## QUALITY ASSURANCE -- NON-CONFORMANCE REPORT

**Report No:** NCR-000827

**Reference Description:** Longitudinal Crack on Cross Bracing Gusset Plate

**Job Name:** SAS Superstructure  
**Document No:** 05.03.06-000784

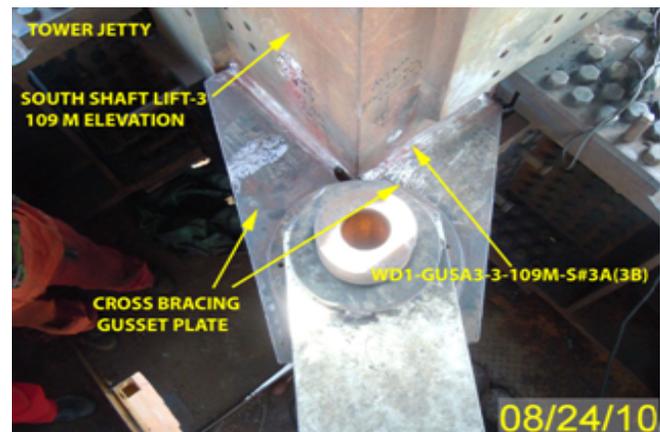
During Magnetic Particle Testing (MT) review of welds on Cross Bracing Gusset Plate, 109 M elevation South Tower Lift-3, this Quality Assurance Inspector (QA) discovered the following issue:

- One (1) longitudinal crack measuring approximately 8 mm in length.
- The member is identified as Cross Bracing Gusset Plate.
- The weld is identified as WD1 – GUSA3 – 3 – 109M – S # 3B.
- The weld is a Complete Joint Penetration (CJP) T-joint joining the Cross Bracing Gusset Plate to South Tower Lift-3 at 109 M elevation.
- The member is Seismic Performance critical Member (SPCM).
- The member is located in Tower Trial Assembly, Heavy Dock.

The Notice of Witness Inspection Number (NWIT) is 006469. The indication is located inside the area that has been previously tested and accepted by ZPMC Quality Control (QC) personnel. As per the contract documents, ZPMC's QC personnel are required to perform 100% MT inspection of these welds.

AWS D1.5 (02) Section 6.2.6.2 – “Welds that are subject to MT in addition to visual inspection shall have no cracks”.

**Reference Resolution:** ZPMC has repaired this missed indication and is providing NDT to show that the repair was successful.

This proposed resolution is acceptable. The documentation received is sufficient and the Department concurs that Non-Conformance ZPMC-0789 is closed.

Reference Description: Longitudinal Crack on Cross Bracing Gusset Plate

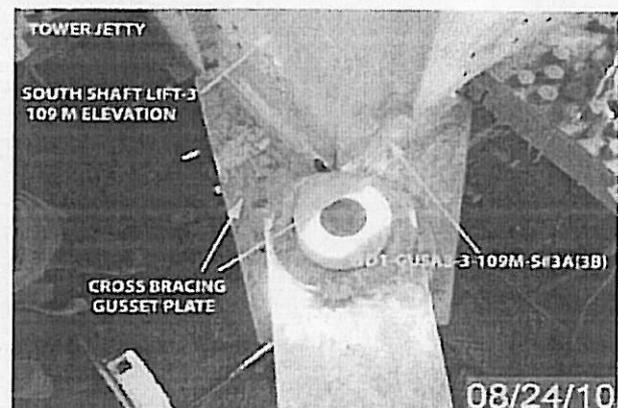
During Magnetic Particle Testing (MT) review of welds on Cross Bracing Gusset Plate, 109 M elevation South Tower Lift-3, this Quality Assurance Inspector (QA) discovered the following issue:

- One (1) longitudinal crack measuring approximately 8 mm in length.
- The member is identified as Cross Bracing Gusset Plate.
- The weld is identified as WD1 - GUSA3 - 3 - 109M - S # 3B.
- The weld is a Complete Joint Penetration (CJP) T-joint joining the Cross Bracing Gusset Plate to South Tower Lift-3 at 109 M elevation.
- The member is Seismic Performance critical Member (SPCM).
- The member is located in Tower Trial Assembly, Heavy Dock.

The Notice of Witness Inspection Number (NWIT) is 006469. The indication is located inside the area that has been previously tested and accepted by ZPMC Quality Control (QC) personnel. As per the contract documents, ZPMC's QC personnel are required to perform 100% MT inspection of these welds.

AWS D1.5 (02) Section 6.26.2 - "Welds that are subject to MT in addition to visual inspection shall have no cracks".

Contractor repaired the weld and NDT report provided which showed the weld is acceptable. Contractor reprimanded the inspector involved.
